Job Ref: 8827
19 September 2018

**Updated Development Application
No. 7 Avonmore Terrace, Cottesloe**

DRAWN CBL	DATE JUNE 2018	SHEET NO. SK4
SCALE as shown	JOB NO. 2sk1711-1670L	PRINT 2/08/2018
THIS DESIGN IS THE PROPERTY OF HORIZON DESIGN AND SHALL NOT BE REPRODUCED WITHOUT PERMISSION. © 2017

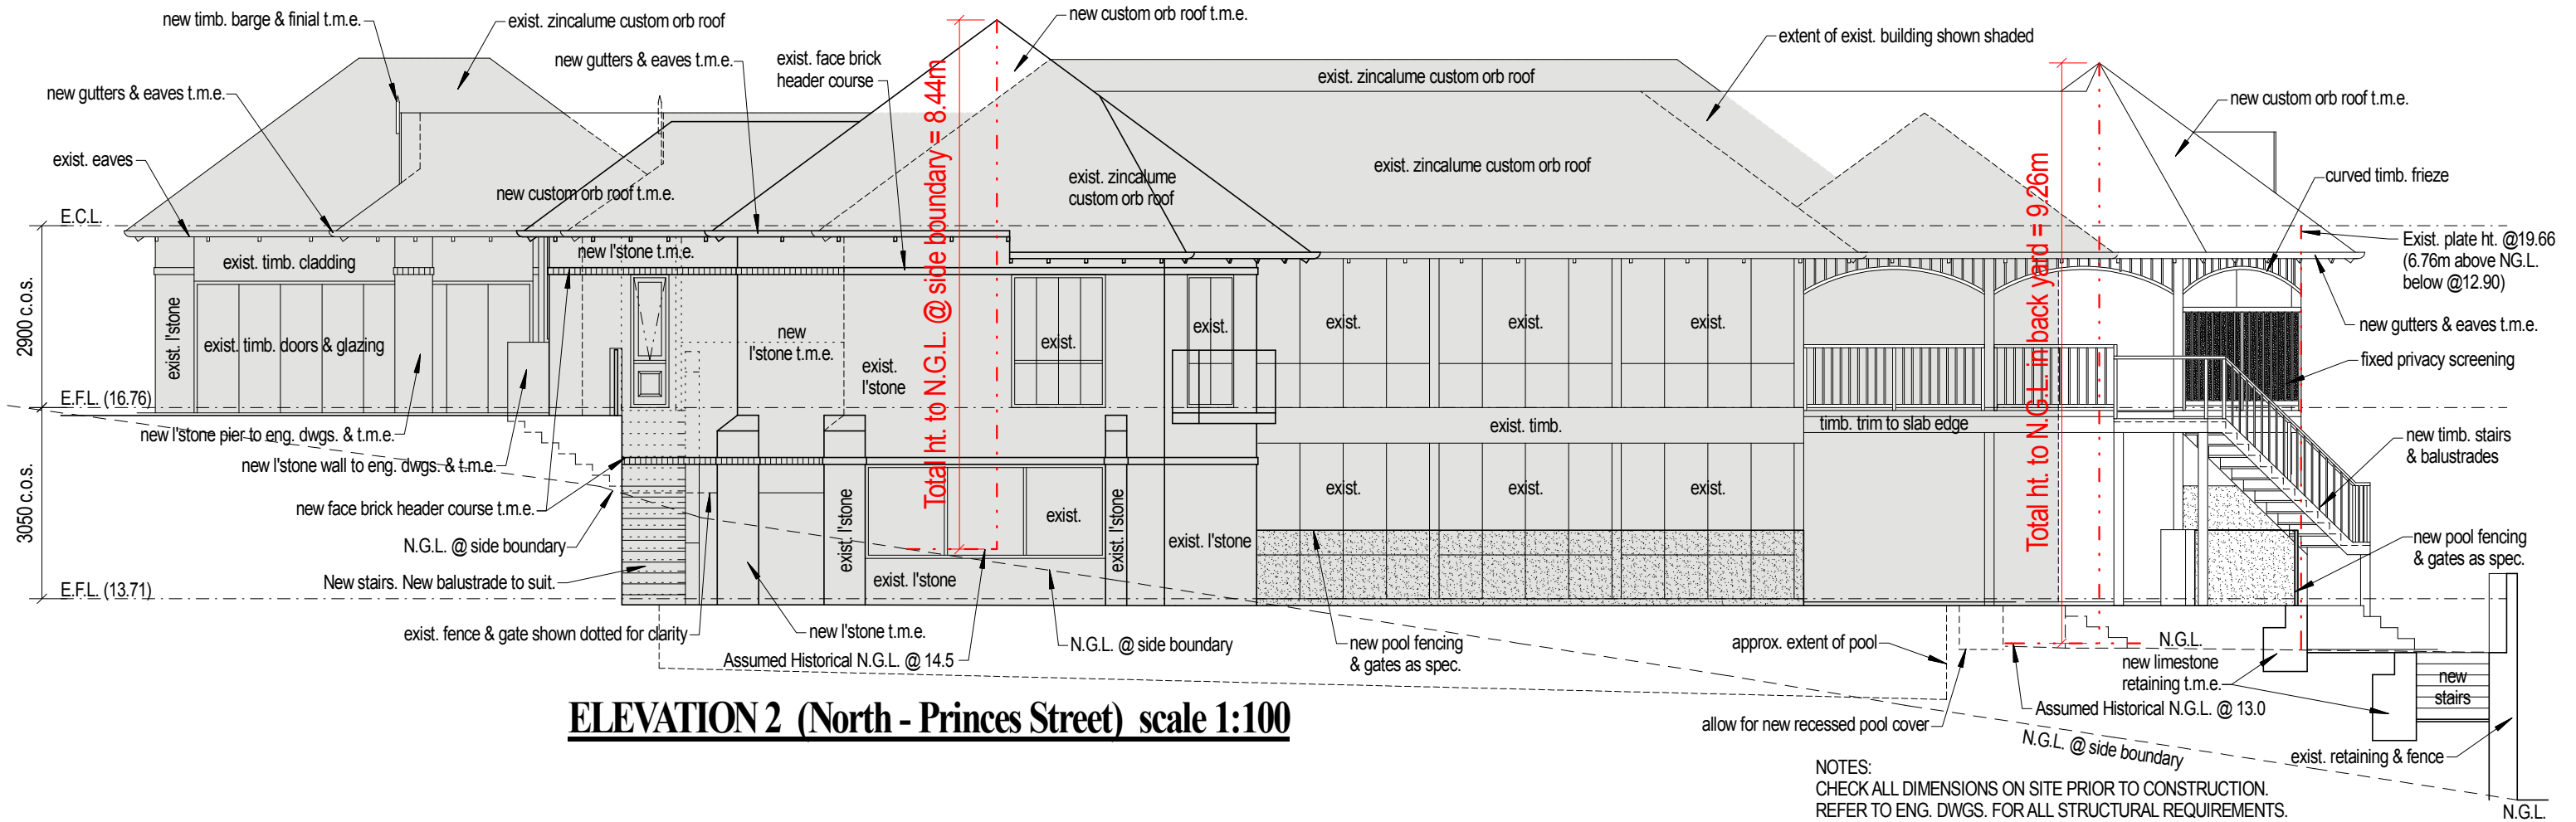
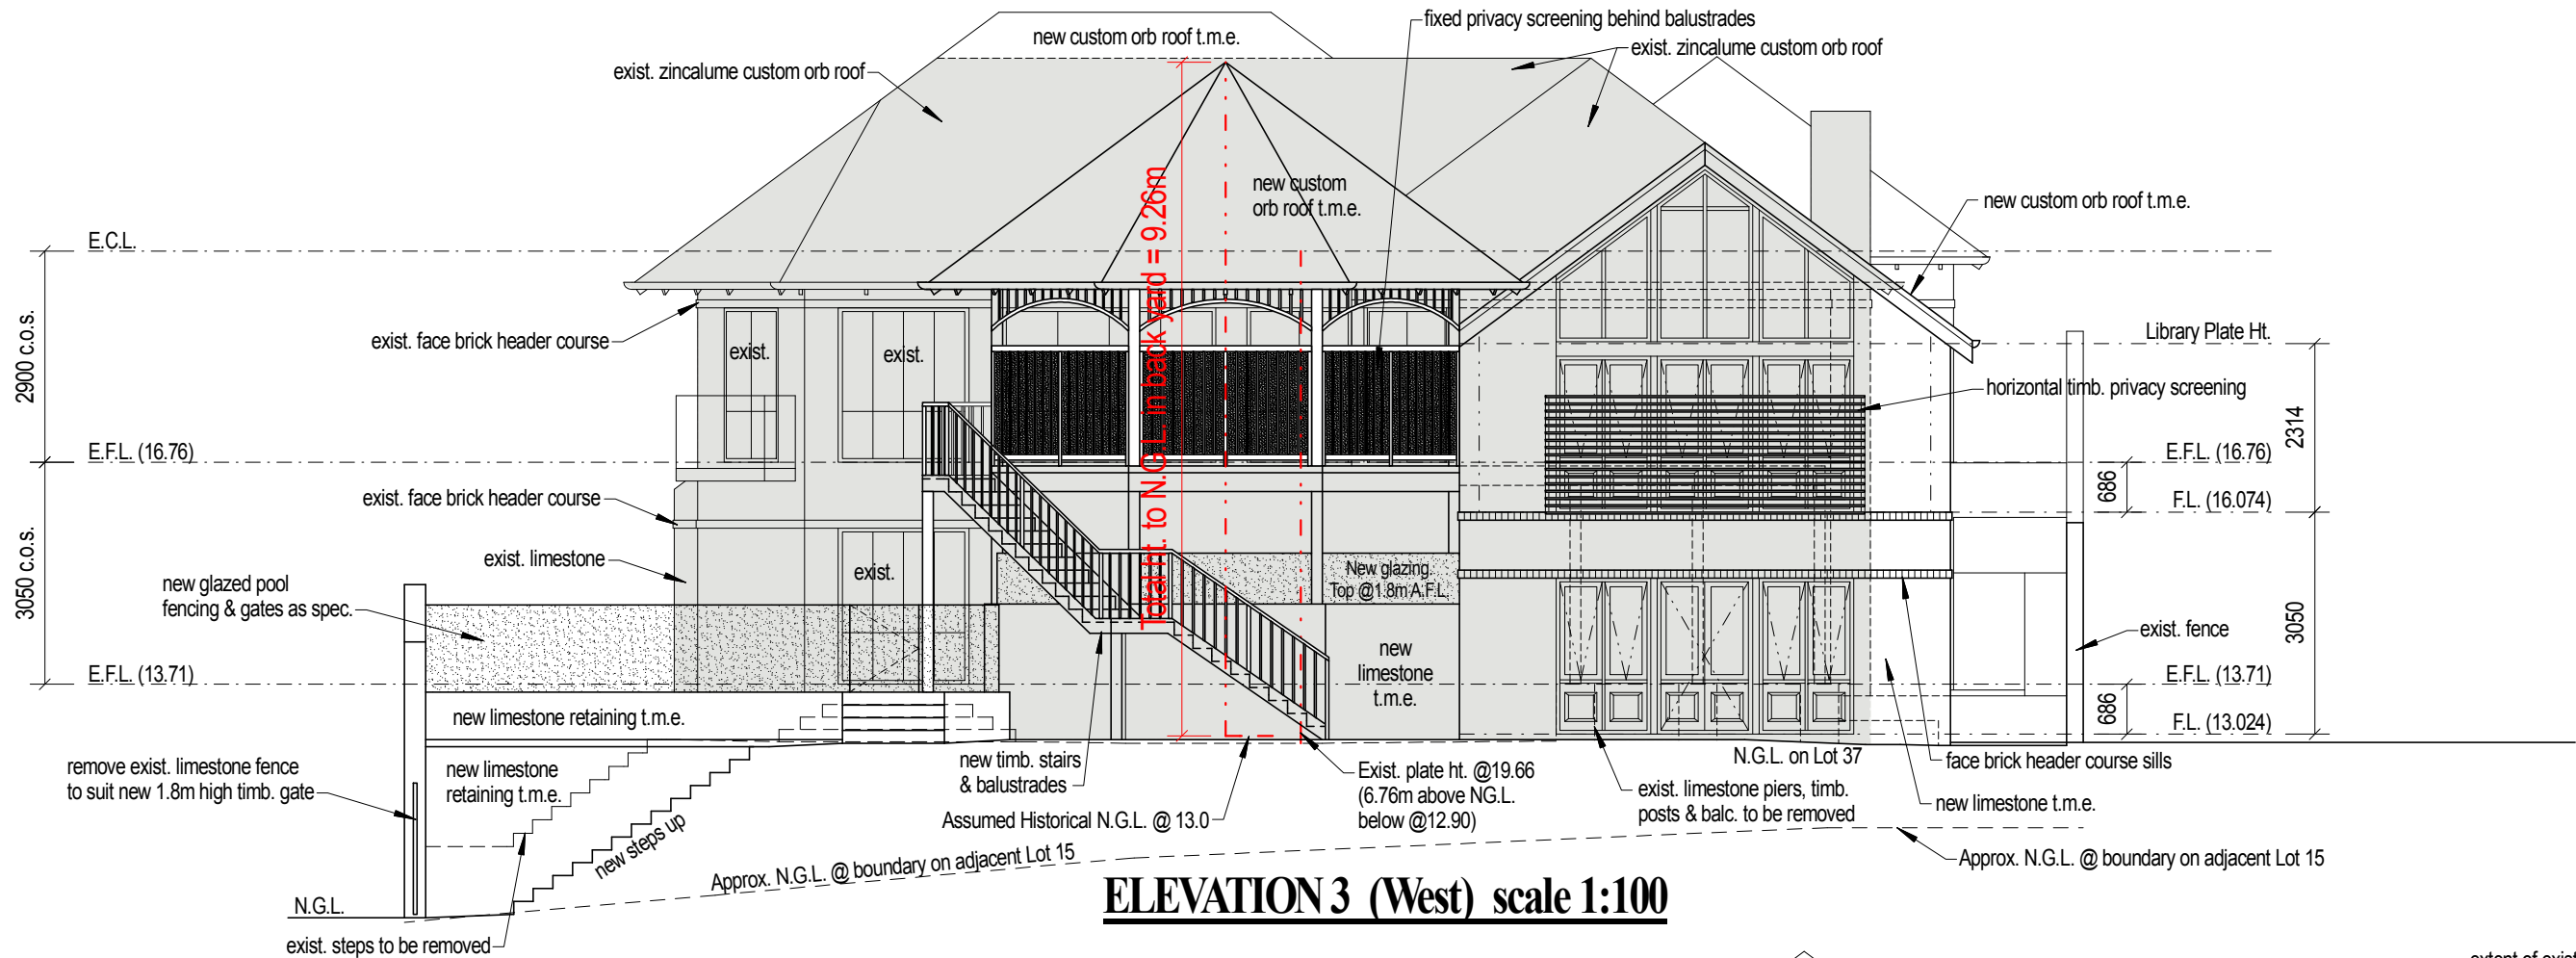
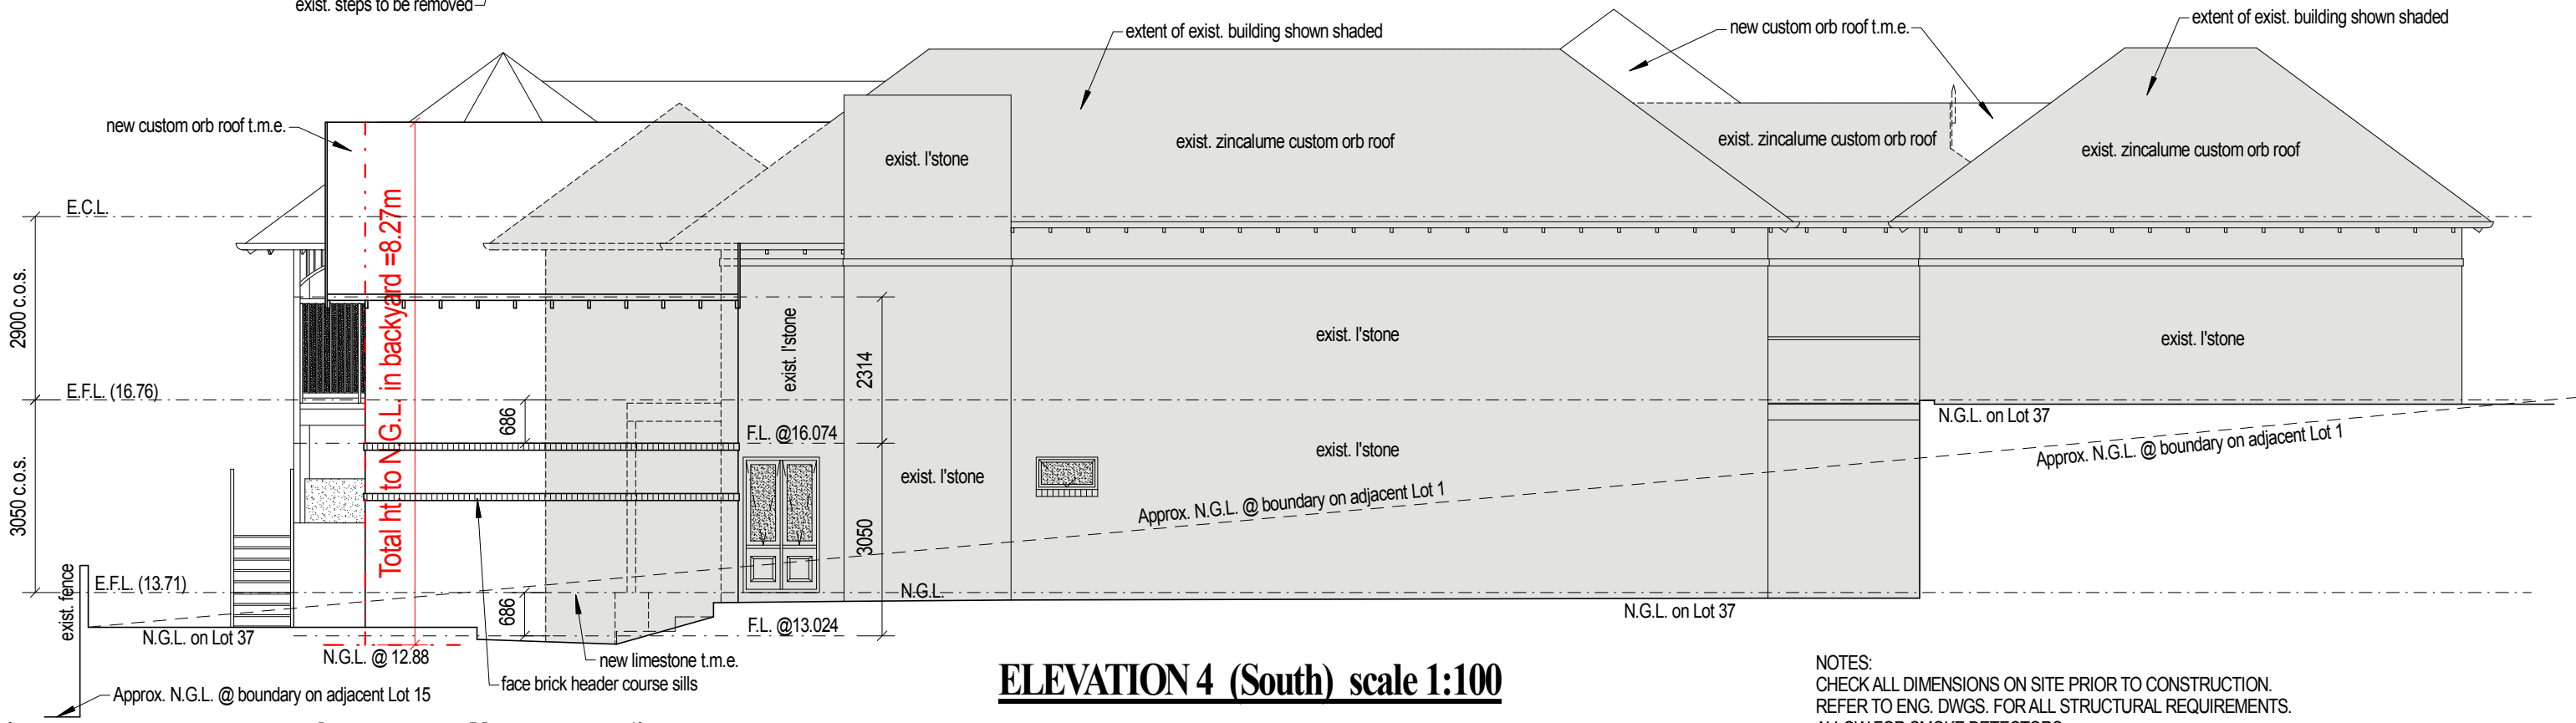
As demonstrated in Plan Sheet Nos. SK4 and SK5 of the development plans at Attachment 1, the additions to the proposed dwelling are generally within the 6.0 metre maximum wall height (to level of roof) and 8.5m maximum height as specified within Clause 5.7.2 of LPS3, aside from the location of the proposed balcony adjacent to Princes Street. In this location the development would have a maximum wall height of 6.0 metres to the roof and 6.76 metres when measured to the plate height of the wall; and a maximum height of 9.26m above the Natural Ground Level, being 0.76m above the 8.5m standard.

In view of the above, the proposed balcony requires consideration against the relevant provisions of Clause 5.7.5 of LPS3. The provisions within this clause are detailed below in bold and italic font, together with an assessment of the proposal for each:

DRAWN CBL	DATE JUNE 2018	SHEET NO. SK7
SCALE as shown	JOB NO. 2sk1711-1670M	PRINT 26/11/2018
THIS DESIGN IS THE PROPERTY OF HORIZON DESIGN AND SHALL NOT BE REPRODUCED WITHOUT PERMISSION. © 2017

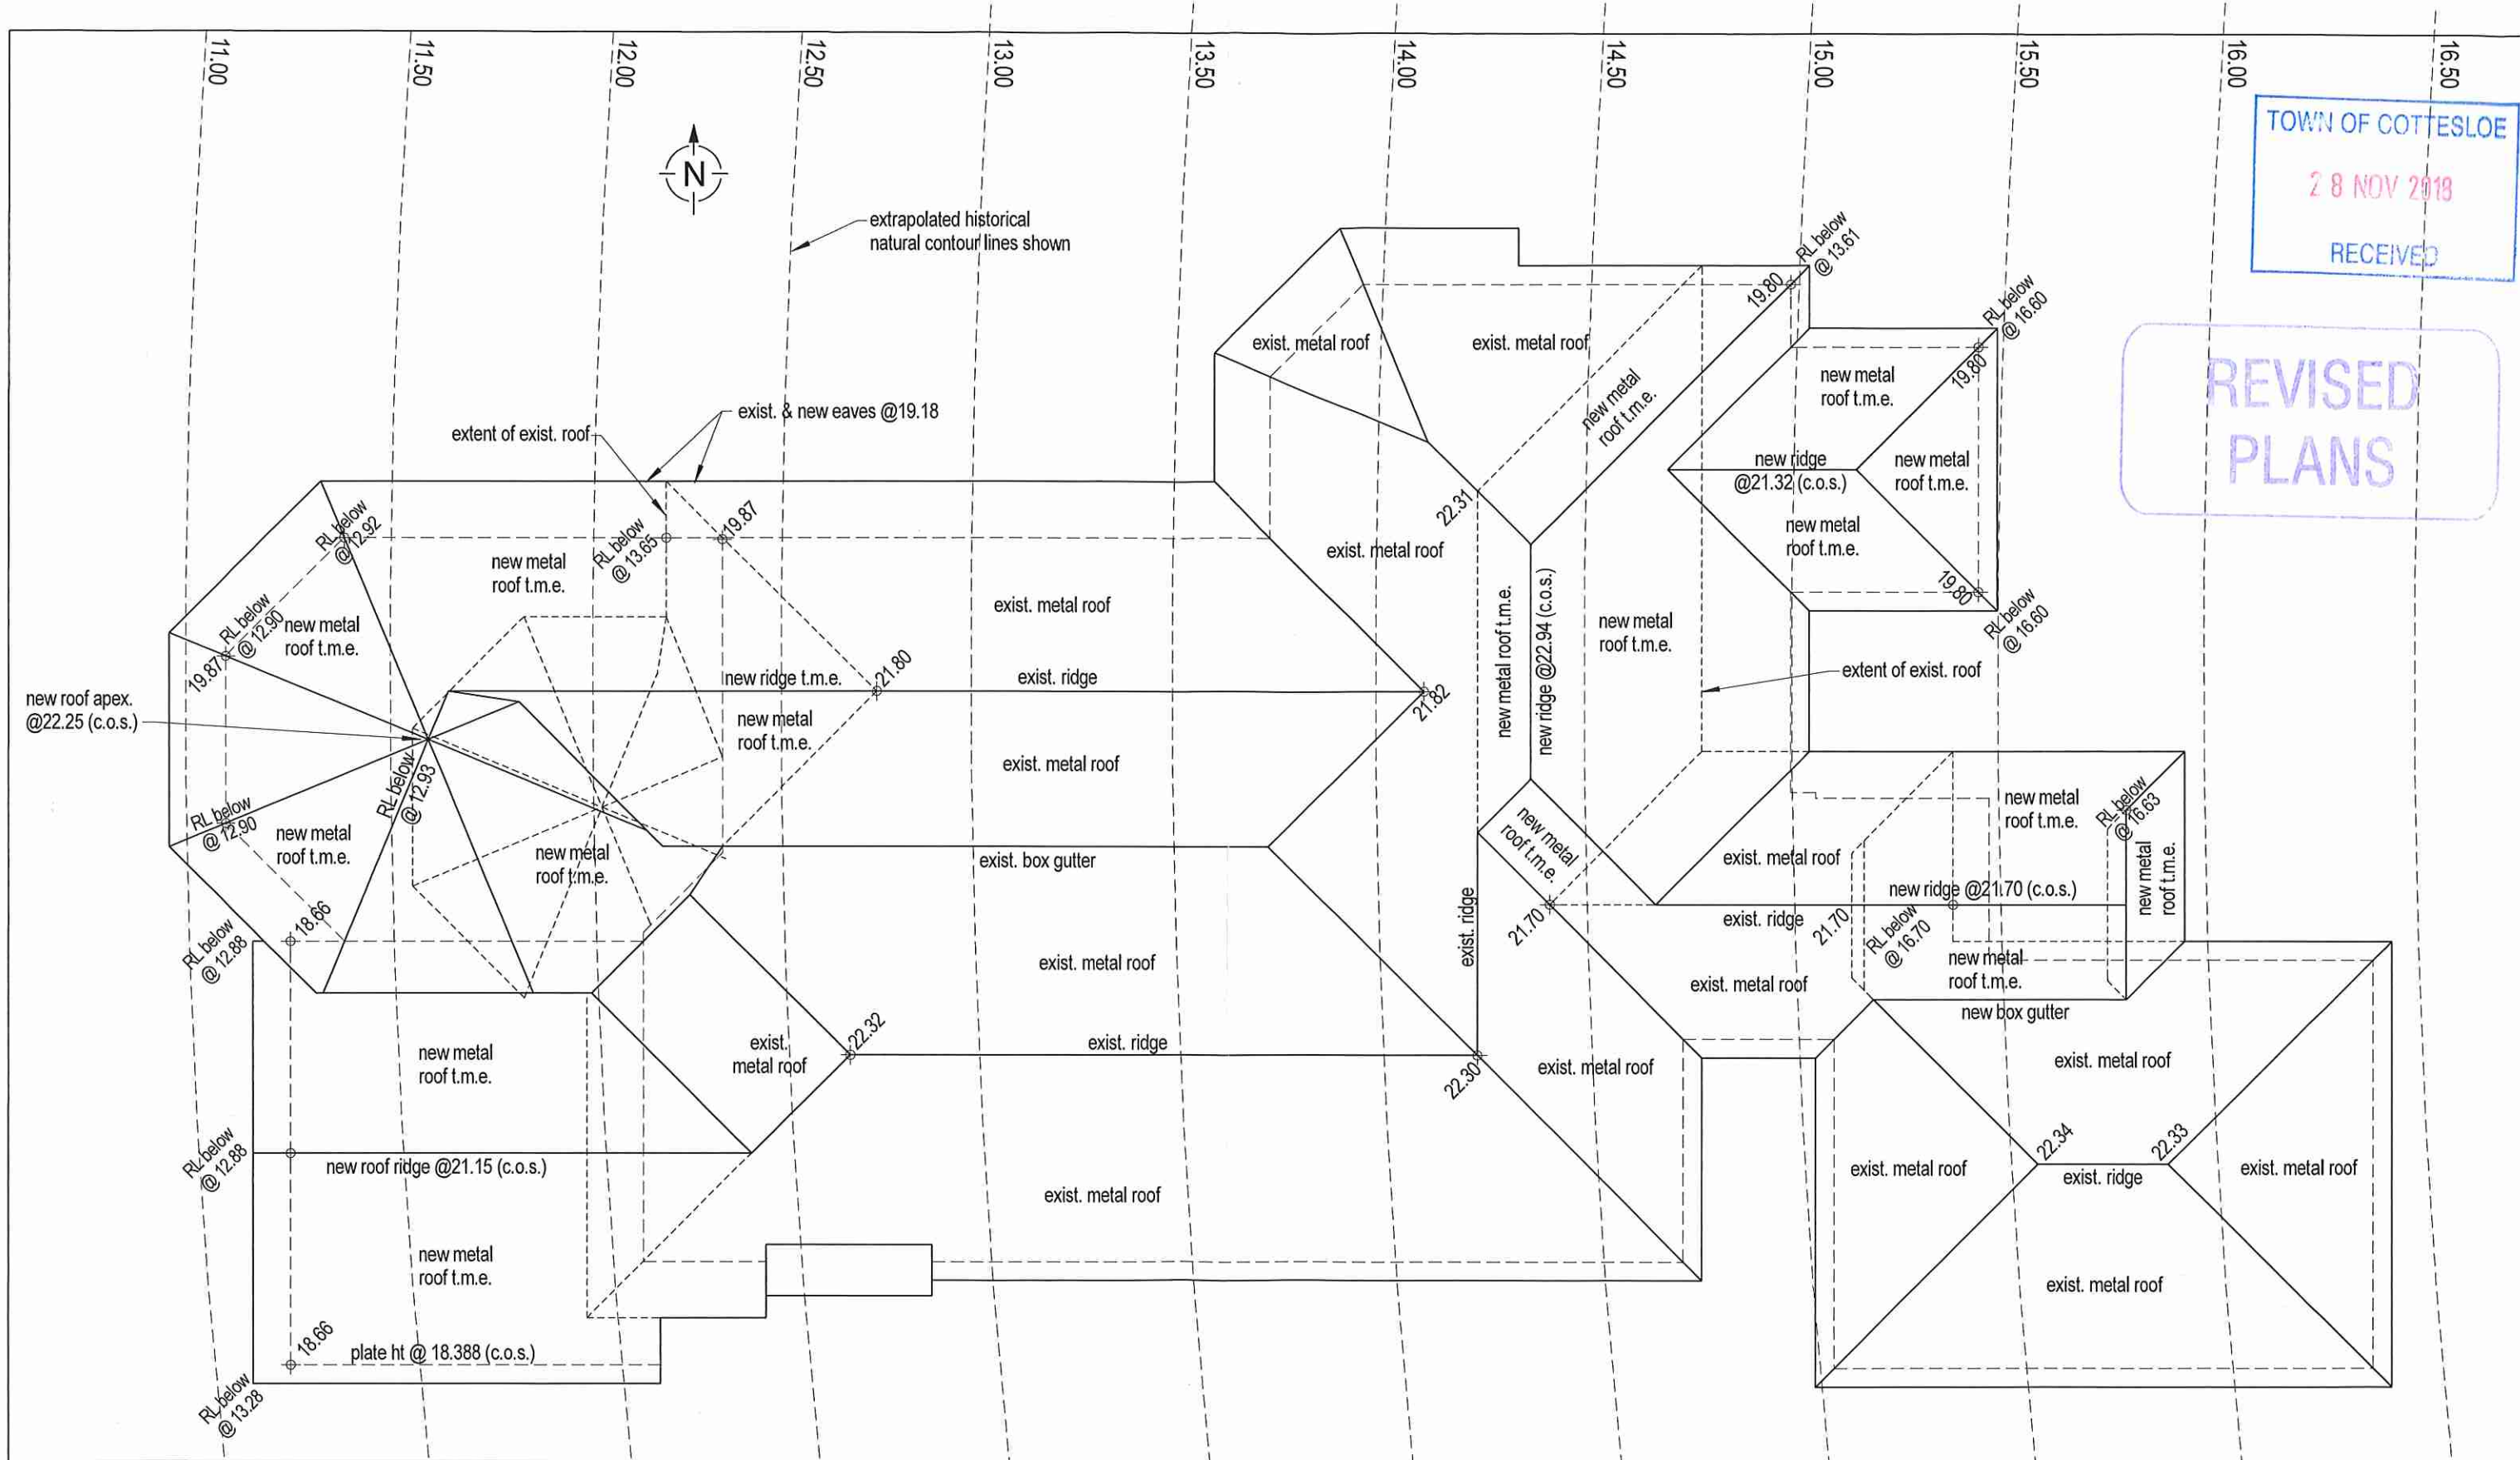
We consider both the new library and balcony extension to be over height based on the natural ground levels represented by the contours overlayed on the roof plan (SK7). Utilising these contours, the maximum height of the proposed extensions is as follows:
